4th Session SEISMIC EFFICIENCY OF LARGE STRUCTURES (RECOMMEN
DATIONS, CHECKING AND SURVEILLANCE)

DISCUSSION

Principal stresses σ_1, σ_2 produced by hydrostatic pressure, according to the three analysed variants.

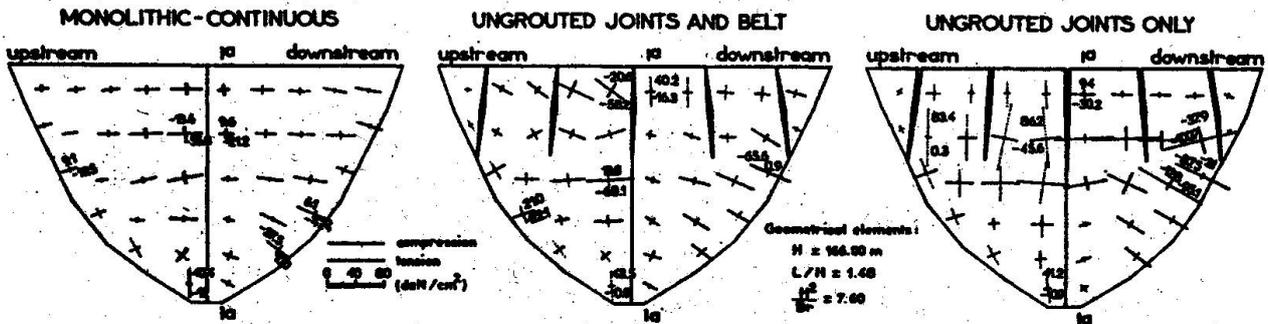
I believe that the ordinates of fig. 4 are all ten times too large and a decimal point should be added; also in fig. 7 I find it difficult to understand the large horizontal stresses in the area where the joints are ungrouted.

The dam structure discretization has been carried out through Clough-Fellipa thin shell finite elements, according to the SAP IV program /6/. The computer program gives out stresses within the element centers. Therefore, in fig. 7, the horizontal and vertical stresses are represented for the medium cross-section of the dam central block (cross-section a-a).

As to have a more complete picture upon the stress distribution of the three considered schemes (monolithic, partial grouted joints with and without stiffening crest belt), in the hereby enclosed figure the principal stresses σ_1, σ_2 are presented, yielded by the hydrostatic pressure with the reservoir level up to the dam crest.
